# FMM230 Product Change Notifications

**Product change notifications (PCN)** is the way of informing customers of upcoming changes related to Teltonika products. This includes outward appearance adjustments, hardware improvements, firmware changes, changes to package contents, etc. This page stores information regarding changes to the FMM230 tracking device. Below you will find a list of both upcoming and already implemented changes sorted from newest to oldest (top to bottom).

2024.01.22: Modified battery placement within the casing

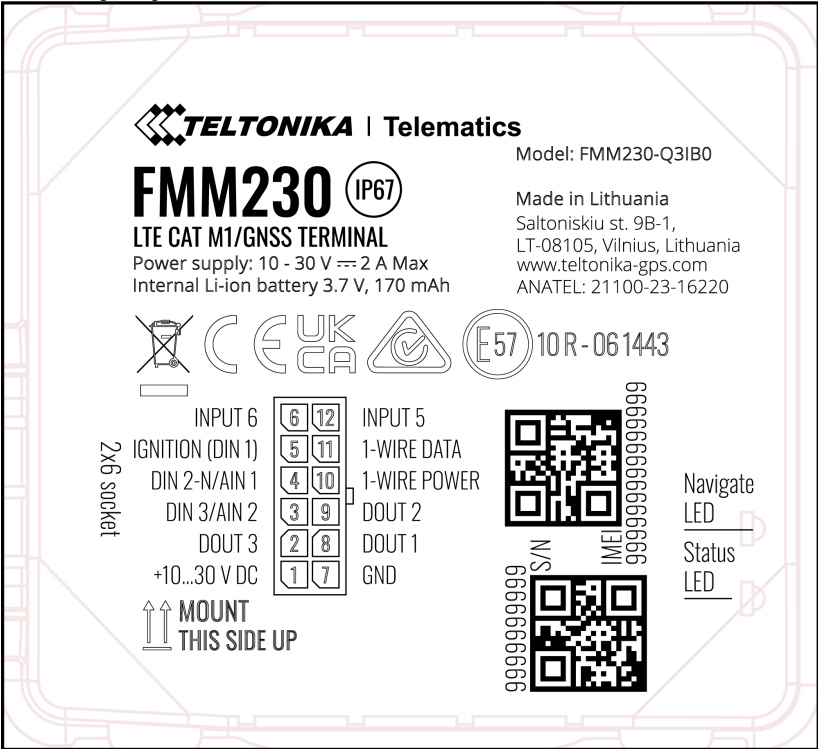
We would like to inform you that starting from January 2024, there will be a small change in the FMM230 devices casing. We have adjusted the battery placement and increased PCB guide height within casing. This modification was essential to enhance our manufacturing process.

Change type	Optimizing robotic battery placement process within casing	
	The modifications will not impact the place of the battery or PCB within the FMM230 device.	
	New Version:	
Detailed description	Old Version: <div><div><div></div><div></div></div></div>	<div><div><div></div><div></div></div></div>

Change reasons	1. Modified battery placement within the casing. 2. PCB guide height increased for easier assembly. 3. Improved manufacturing process.	
Product release date	January, 2024	
<b>Affected products</b>		
Model	Affected order codes	Order code changes
FMM230	FMM230 all codes	Modified battery placement and PCB guide height within the casing.
<b>Change impact</b>		
Risk assessment	During transition period clients might receive devices with previous casing design. The transition period can last from January to February inclusive.	
Suggested implementation plan	No implementation plan is needed.	
<b>Acknowledgement of PCN receipt</b>		
If no feedback is received within two weeks after the issue date of this notification - Teltonika may accept that this change has tactically accepted and can implement the change as indicated above.
